SUBJECT: TEXAS ENGINEERING EXPERIMENT STATION/TEXAS A&M UNIVERSITY
SYSTEM – ISSUANCE OF AMENDMENT NO. 18 TO RENEWED FACILITY
OPERATING LICENSE NO. R-83 FOR THE RECEIPT AND POSSESSION OF
THE AGN-201M REACTOR FUEL

Amendment No. 18
Renewed License No. R-83

ATTACHMENT TO LICENSE AMENDMENT NO. 18
RENEWED FACILITY OPERATING LICENSE NO. R-83
DOCKET NO. 50-128

Figure 1 – Fuel Storage Room located in the NSC Reactor Building

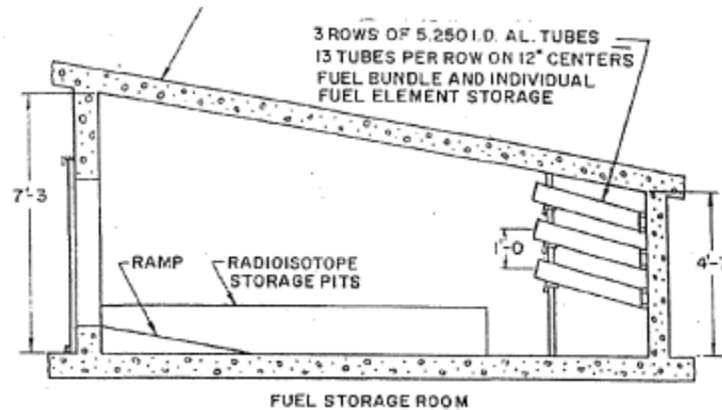
The TEES/TAMUS stated (Ref. 1, 2, and 3) that the administrative controls allow the PuBe neutron source to be stored in the radioisotope storage pits in the TRIGA fuel storage room (see Figure 1) or in its own storage container that provides neutron and gamma shielding for the source. The quantity of plutonium present in the neutron source will not contribute to the total k_{eff} in the room because the total quantity of Pu is very small. Therefore the exact location of the PuBe source in the room does not impact the criticality analysis for the other material stored in the room and the use of administrative controls is acceptable. Placing the PuBe source in the administratively controlled location provides additional isolation from the other SNM in the room, but is not required to ensure compliance with the k_{eff} fuel storage TS.

The radiological procedures and policies will ensure the PuBe source is stored in a manner that is in compliance with the 10 CFR Part 20 requirements. The planned storage of the PuBe source in its own shielded container or the radioisotope storage pits in the NSC fuel storage room (see Fig. 1) are locations that meet the requirements in 10 CFR Part 20.
